**VILLAGE OF DOWNERS GROVE  
REPORT FOR THE VILLAGE COUNCIL MEETING  
FEBRUARY 21, 2012 AGENDA**

<b>SUBJECT:</b>	<b>TYPE:</b>	<b>SUBMITTED BY:</b>
Annexation with Rezoning to B-2, Lot Consolidation and Special Use for a drive-through use	<ul style="list-style-type: none"> <li>✓ Resolution</li> <li>✓ Ordinance</li> <li>Motion</li> <li>Discussion Only</li> </ul>	Tom Dabareiner, AICP Community Development Director

A resolution and ordinances have been prepared for annexation, rezoning, lot consolidation and special use for a Walgreens store at the northwest corner of 63<sup>rd</sup> Street and Woodward Avenue.

At the February 7, 2012 Village Council meeting, the Council discussed annexation, rezoning, lot consolidation and a special use for a Walgreens store at the northwest corner of 63rd Street and Woodward Avenue. The Council asked several questions, requested additional information and suggested changes to the plans.

LANDSCAPE PLAN  
SCALE: 1" = 20'-0"

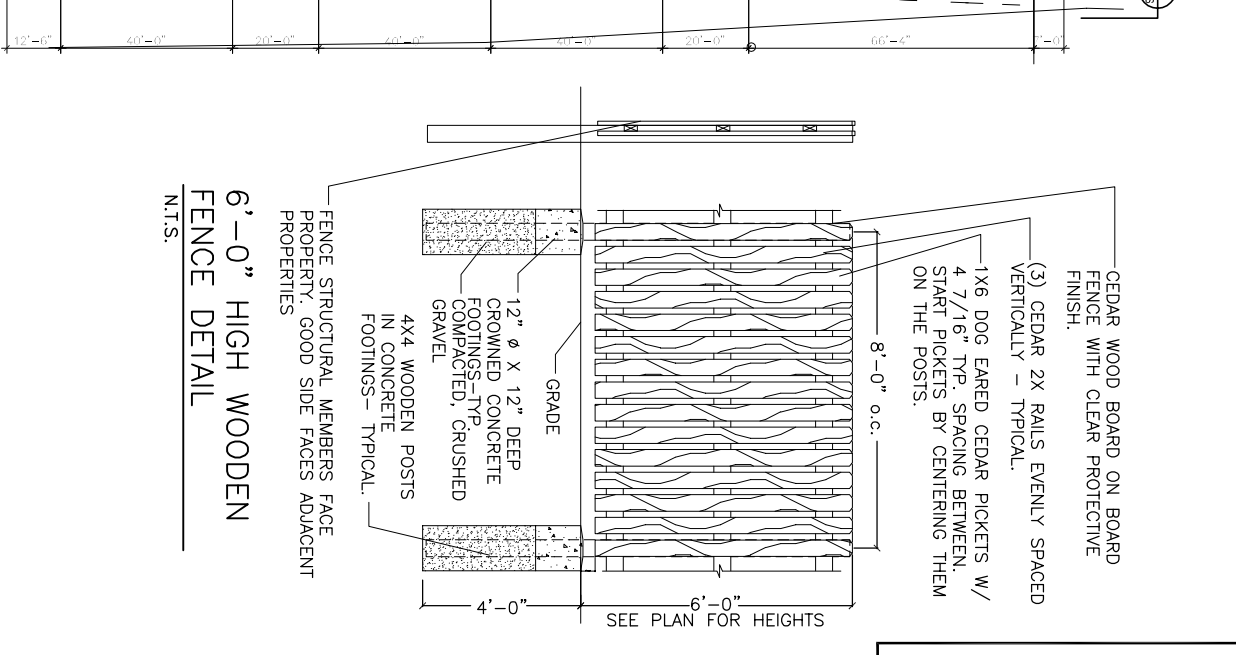
Increase the landscaping along the north lot line – The reduction of five feet in the north drive aisle allows for five additional feet of landscaping. The landscape plan includes nine additional deciduous trees between the two rows of arborvitae and the six-foot wood fence. The revised landscaping plan is attached.
